**RE: Nelson Aggregate – Burlington Quarry
Aggregate Resources Act Site Plan Amendment Application
Part Lot 1 & 2, Concession 2, City of Burlington (Geographic Township of Nelson) Region of
Halton – Licence Nos. 5499 and 5657
OUR FILE 9135D**

Nelson Aggregate Co. has filed a Site Plan Amendment Application to the Ministry of Northern Development, Mines, Natural Resources and Forestry (NDMNRF) to integrate the existing Burlington Quarry with the proposed Burlington Quarry Extension.

Site Plan Amendments

OPERATIONAL PLAN
 Drawing No. 2 OF 4

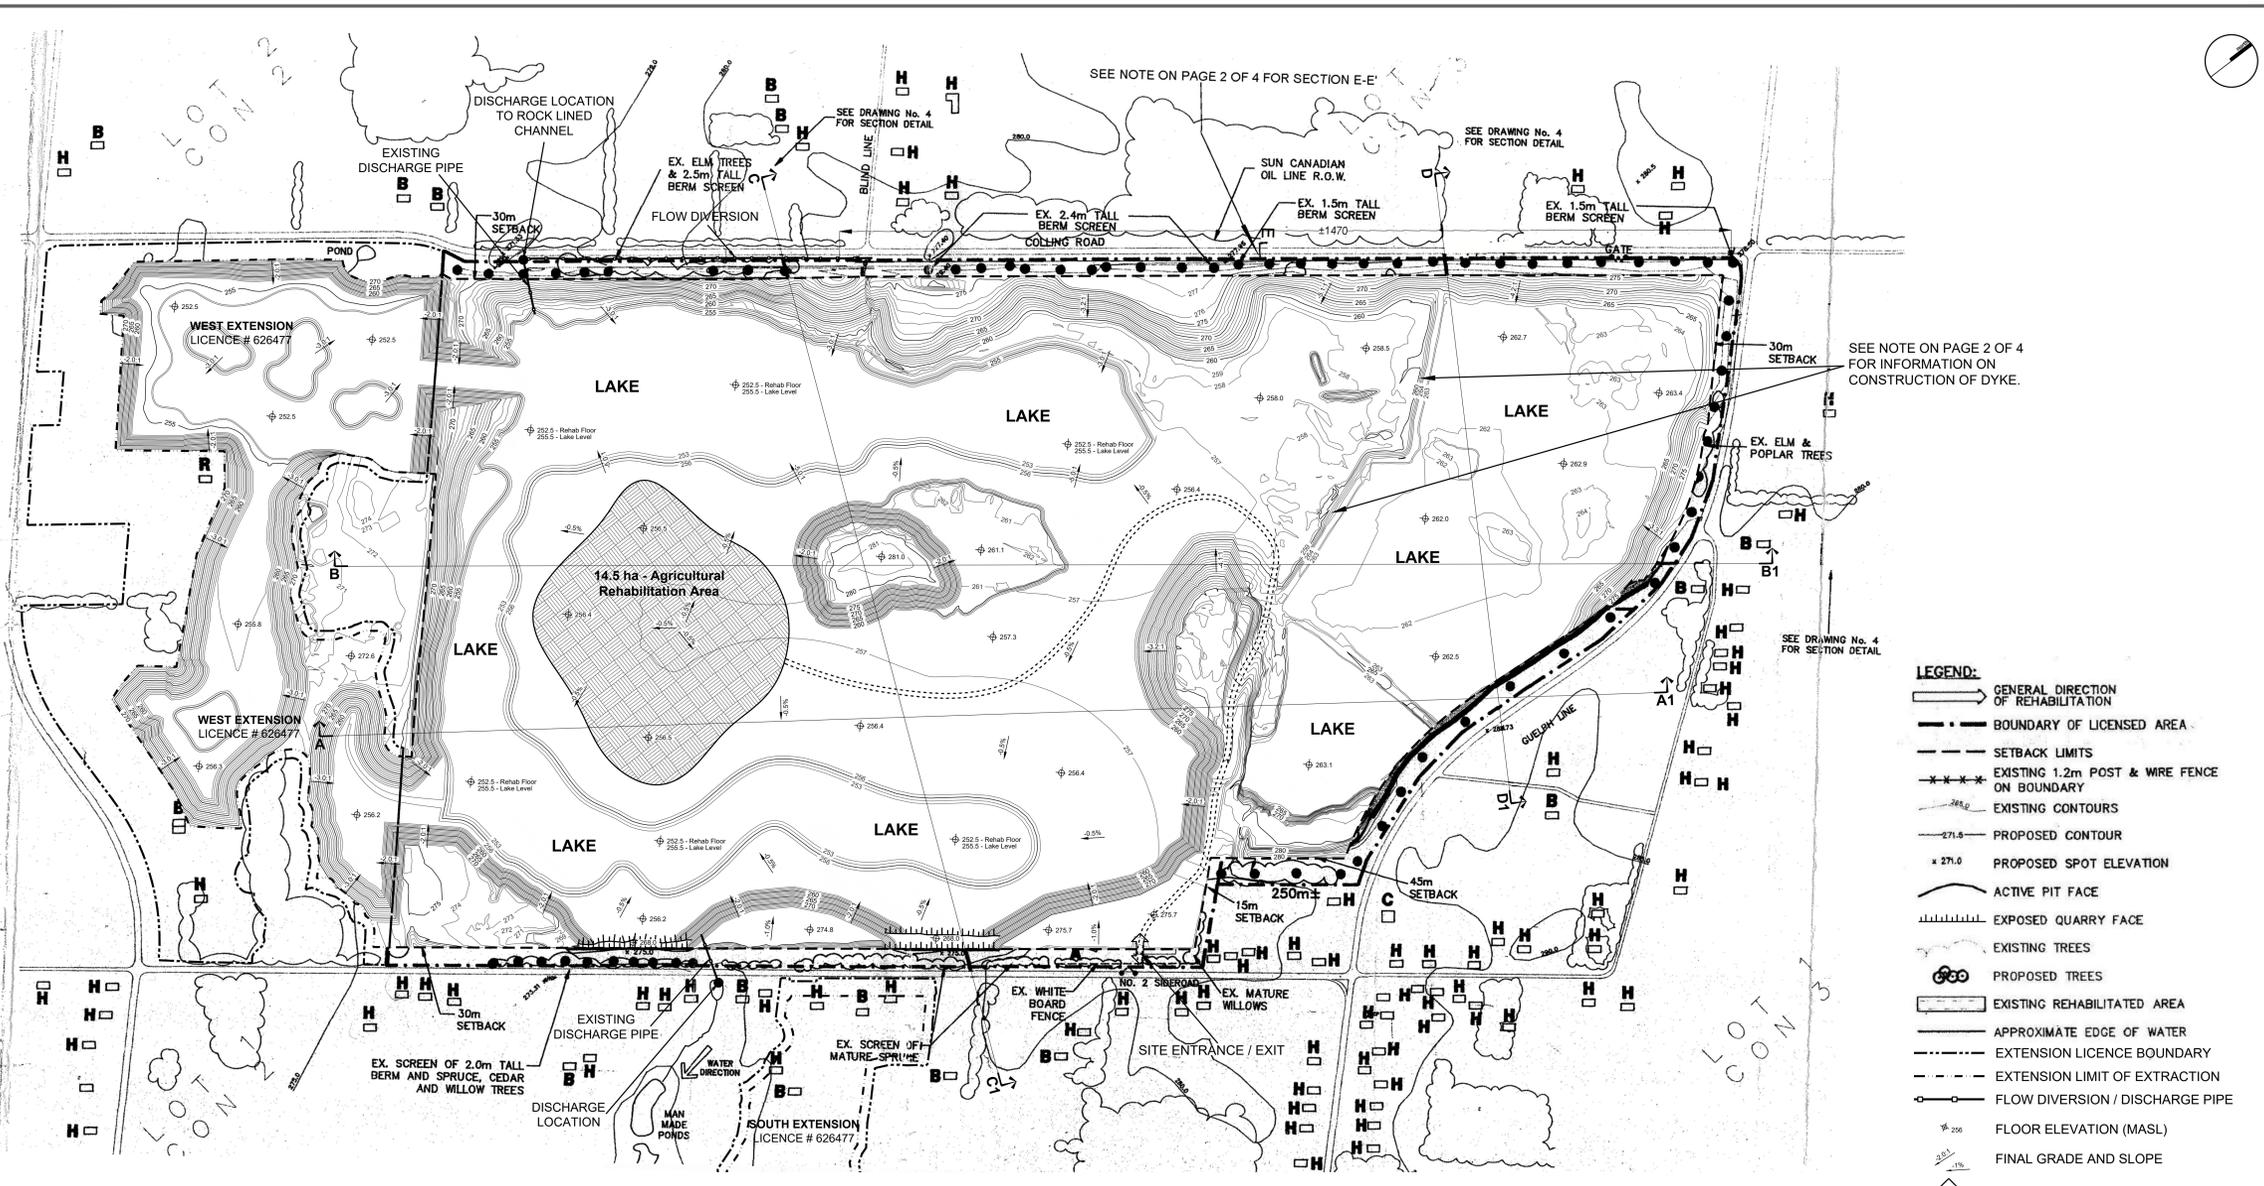
| No. | Date | Description | By |
|-----|----------|---|----------|
| 12 | 21/09/10 | ADD AGRICULTURAL REHABILITATION AREA AND INTERNAL HAUL ROAD | C.P. |

- This plan permits aggregate extracted at the Burlington Quarry Extension to be transported on-site for processing and shipping. The Burlington Quarry South Extension will transport aggregate from an at-grade crossing on No. 2 Sideroad in the location shown on this Plan. The Burlington Quarry West Extension will transport aggregate on the quarry floor within the extraction area connecting the two sites. The final area to be extracted on-site is the southeast corner of Licence No. 5499 after the completion of extraction of the Burlington Quarry Extension.

PLANNING & FINAL REHABILITATION PLAN
 Drawing No. **3 OF 4**

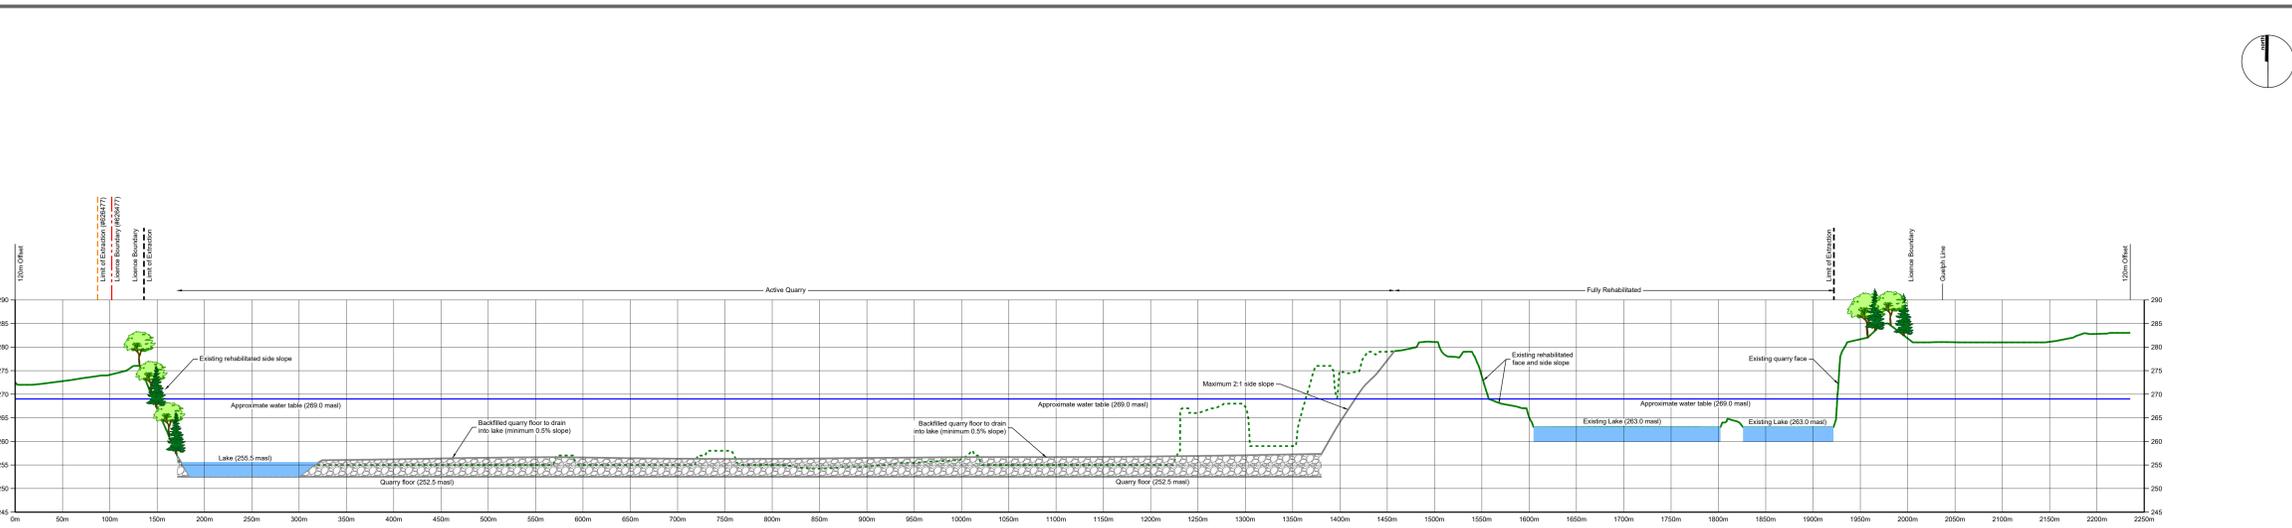
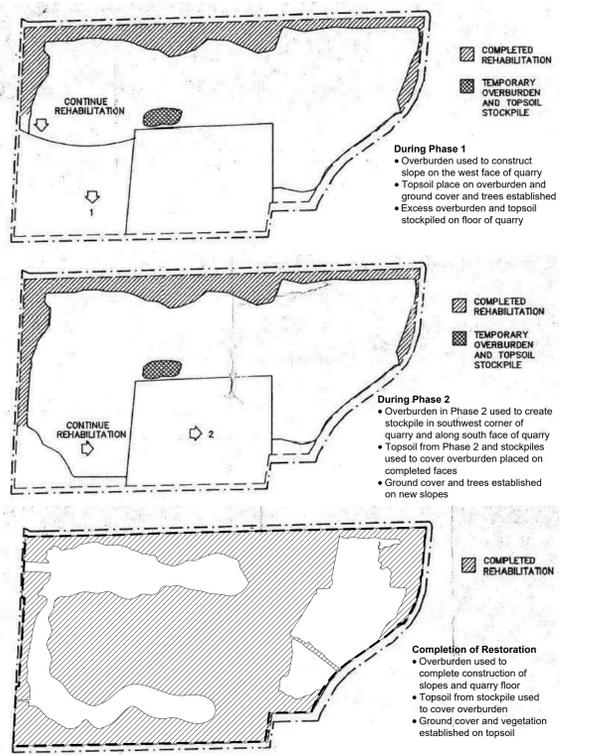
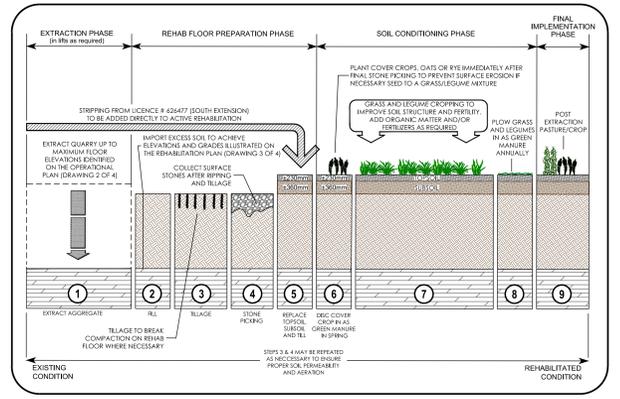
- Agricultural Rehabilitation**
- The Agricultural Rehabilitation Area identified on the plan view shall be established by importing topsoil and subsoil from Licence #626477 and following the Quarry Floor Agricultural Rehabilitation Sequence detail on this drawing.
